Shop Drawing Submittal Review

Project Name: Webster University-**ISB**

Copies	No.	Description
1 PDF	224216P02	(Submittal No.'s)
		(Cannon #22 4216.16-001) - (Paric #15051-) - (WES #607)
		➤ Commercial Sinks
		• Clinical Service Sink CSS-1
		• Scrub Sink SS-1
		• Sink SK-1
		• Garbage Disposer GD-1
		• Sink SK-2
		• Sink SK-3
		• Mop Sink MS-1
		• Kitchen Sinks KS-1, KS-2, KS-3

SPEC SECTION: 22 4216.16
Commercial Sinks

**PFEWB200**

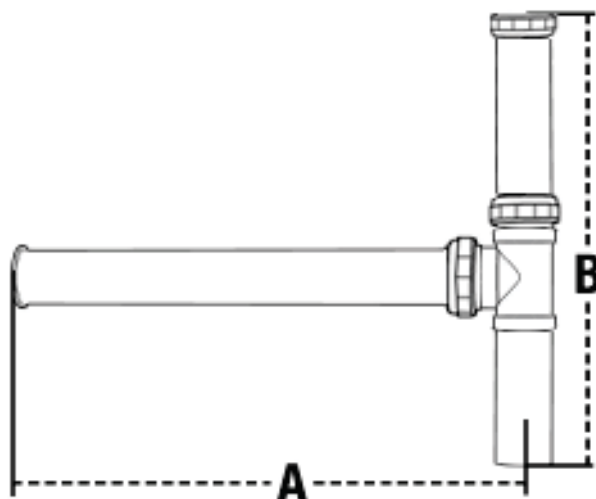
1. Provide under counter waste and supply protective piping covers as required.
Verify requirements with the architectural drawings.
2. Escutcheons are specified to be cast brass. Refer to specification section 220518.
